MEMORANDUM

TO: Karl Dreher
FROM: Cindy Yenter
CC: Brian Patton, Jennifer Berkey, Tim Luke
RE: Water Right Review and Sufficiency of Measuring Devices, Rangen Aquaculture

Sufficiency of Measuring Devices

Water Flow Measurements
Head of Billingsley Creek

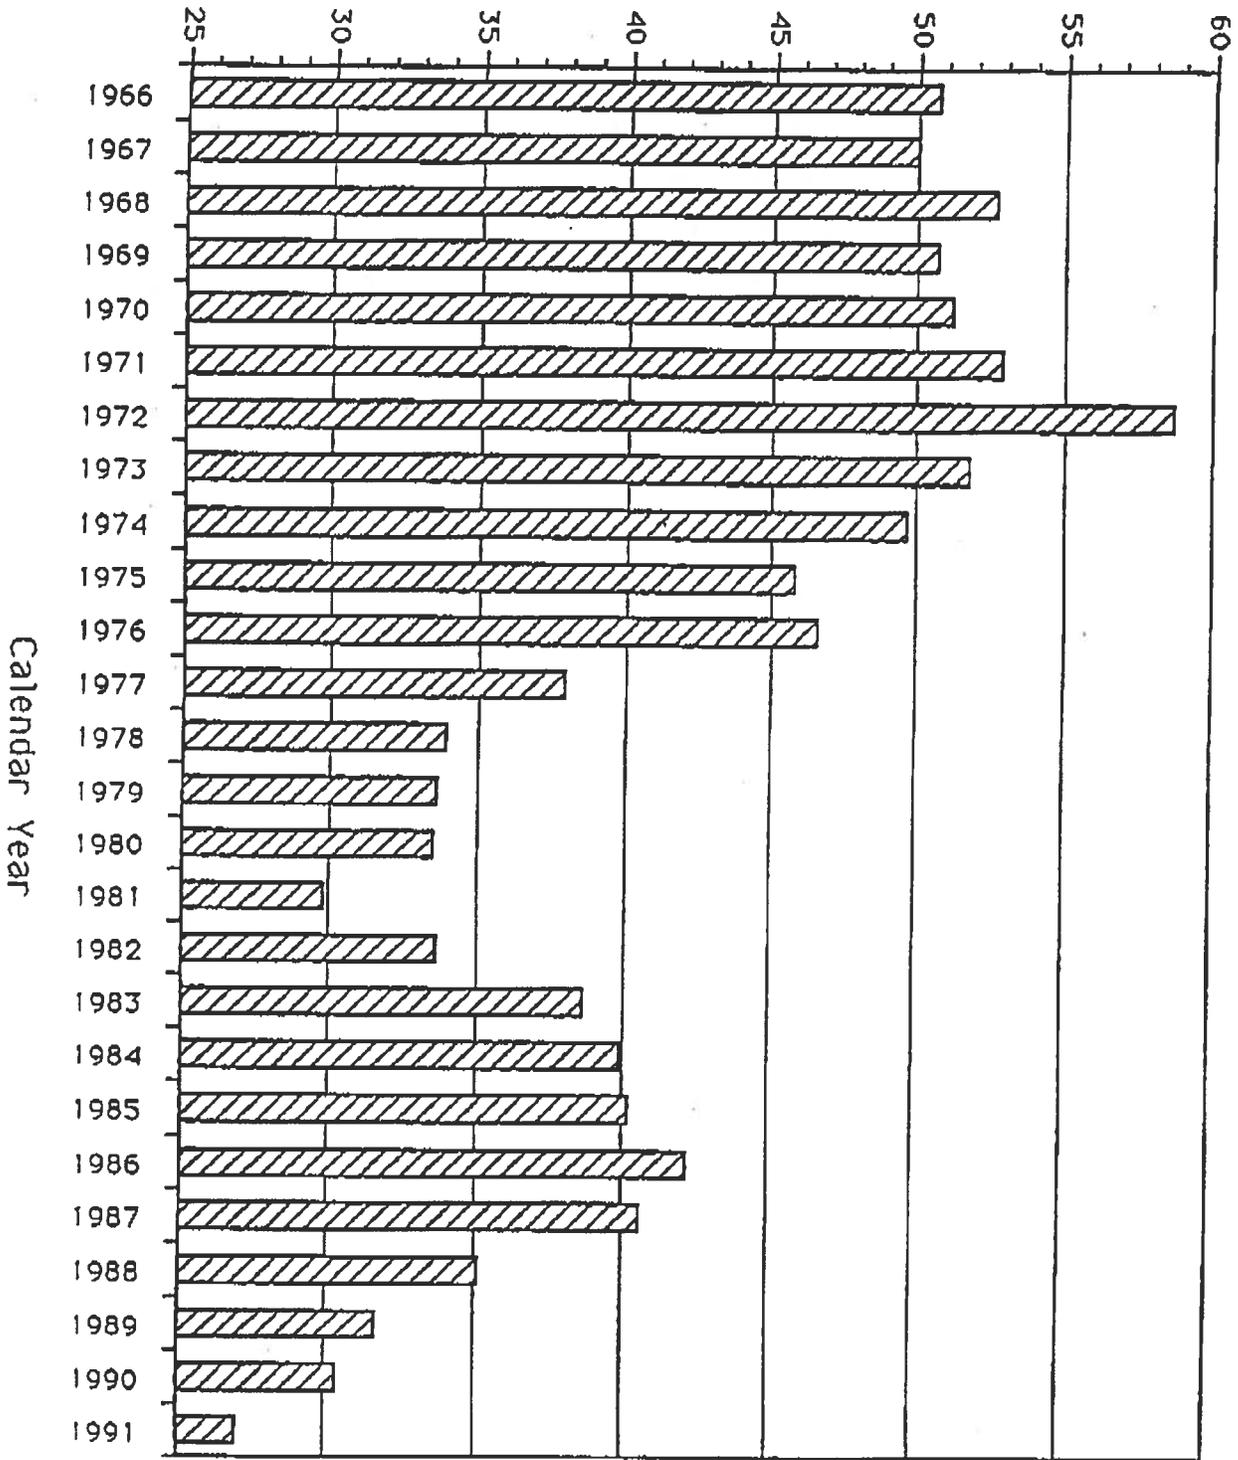
1. A table of monthly average flow measurements from 1966 to 2003, which is titled "Rangen Research Hatchery, total flow measurements"
2. A chart of yearly average flow from 1966 to 1991, titled "Water Flow Measurements, Head of Billingsley Creek"
3. A table of monthly average flow from 1966 to 1991, titled "Head of Billingsley Creek at Curran Tunnel"
4. Copies of handwritten records of weekly flow measurements recorded between 1966 and 2003
5. A sketch of the hatchery facilities

Because the data reported in the table "Rangen Research Hatchery, total flow measurements" do not represent the same parameters each years, this table cannot be used to evaluate Rangen's historical water use. Using the handwritten weekly records, it would be possible to derive a table of average monthly raceway flows that would more closely represent Rangen's historical use between 1981 and 2003. Some data gaps and errors would likely occur in this analysis because some of the handwritten records are not legible. The data sheets for years prior to 1981 are not sufficient to derive monthly raceway data.

1. The monthly average data submitted in the table "Rangen Research Hatchery, total flow measurements" do not represent Rangen's diversion and beneficial use of water and are not consistent in the parameters they represent.
